Item ID: D206-642-341BL Accept ***N900040100*** Setup Start ***NS1***
 Revision ID: Stop ***NS2***
 Item Name: Replacement Skidtube (Fits LH or RH)
 Start Date: 1/28/2016 Start Qty: 1.00 ***1*** Cust Item ID:
 Required Date: 3/3/2016 Req'd Qty: 1.00 ***1*** Customer:
 Reference:

Item Name: Replacement Skidtube (Fits LH or RH)

DRAWING NO. D2650	TITLE 206/407 SKIDTUBE ASSEMBLIES	REV. F	DART AEROSPACE LTD ENGINEERING ORDER		D.E.O. NO. D2650-F-1	SHEET NO. SHEET 1 OF 1	SCALE NTS
DRAWN <i>[Signature]</i>	CHECKED A.P.	MFG. APPR. <i>[Signature]</i>	APPROVED <i>[Signature]</i>		DE APPR. <i>[Signature]</i>		
DATE 12.10.12	DATE 12.10.22	DATE 12.10.22	DATE 12.10.22		DATE 12.10.22

CHANGE C'BORED WELDED CROSSBOLT SPACERS TO SWAGED SPACERS

DETAIL B

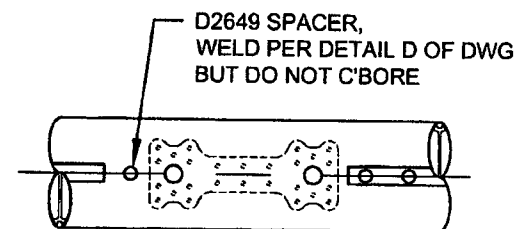
C'BORED HOLES ARE **NOW SWAGED** PER DETAIL G BELOW. FOR THE Ø0.375 HOLE THAT IS NOT C'BORED, WELD PER DETAIL D OF DWG (SEE AMENDED DETAIL B FOR REFERENCE).

AMENDMENT TO DETAIL B
NOT TO SCALE

DETAIL G

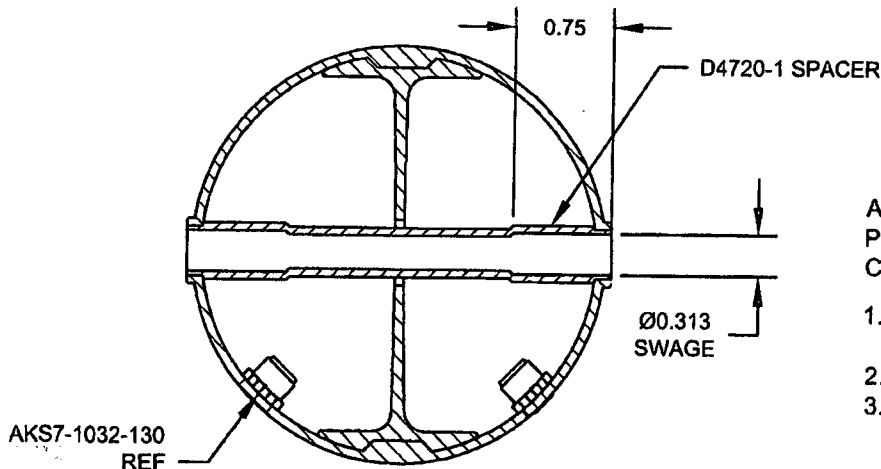
ADD DETAIL G BELOW, WHICH IS THE SAME SECTION VIEW AS DETAIL D OF DWG.

FOR HOLES THAT ARE CURRENTLY C'BORED ONLY
NOT TO SCALE

AFTER DRILLING AND BENDING ASSEMBLY
PERFORM THE FOLLOWING FOR Ø0.375 HOLES THAT ARE
CURRENTLY C'BORED:

1. INSERT D4720-1 SPACER, 16 PL (-1) OR 17 PL (-3)
OR 19 PL (-5) OR 23 PL (-7)
2. SWAGE TO Ø0.313 X 0.75 DP PER QSI 002
3. TRIM / GRIND FLUSH PER QSI 002
